August 9, 2023

Site Plan Review

Site: 27300 Southfield Road
Applicant: Abro Property Group
Plan Date: July 26, 2023
Zoning: MX Mixed Use District
Parcel ID: 24-13-353-001
Proposal: Interior / Exterior Commercial Building Renovation

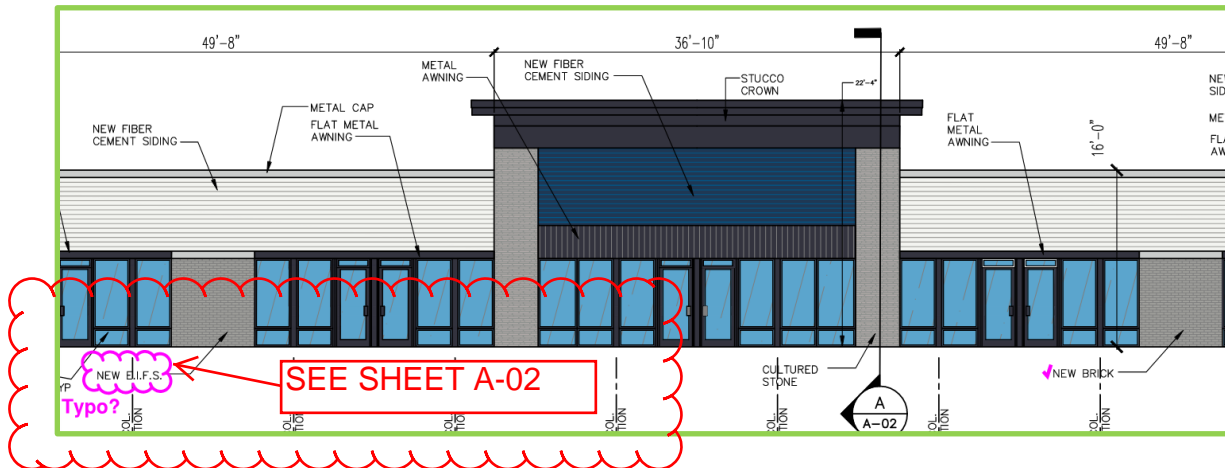
4. **Building Materials (Section 5.4).** Except as otherwise provided in this ordinance, **on all permanent buildings, exterior wall construction and exposed, exterior chimneys shall be either brick, natural stone, masonry materials other than brick, or a combination thereof, provided all such materials comply with the specifications outlined in this section.**

*The updated elevations show changes to the building materials; however, **E.I.F.S. is still labeled in areas that may intend to be brick, as highlighted in the image below.** Fiber cement siding is used among much of the façade that is not accented by brick or cultured stone. Fiber cement is a masonry product designed to replace traditional wood and vinyl elements, but due to the higher sustainability it is often used in combination with or in place of traditional brick and stone.*
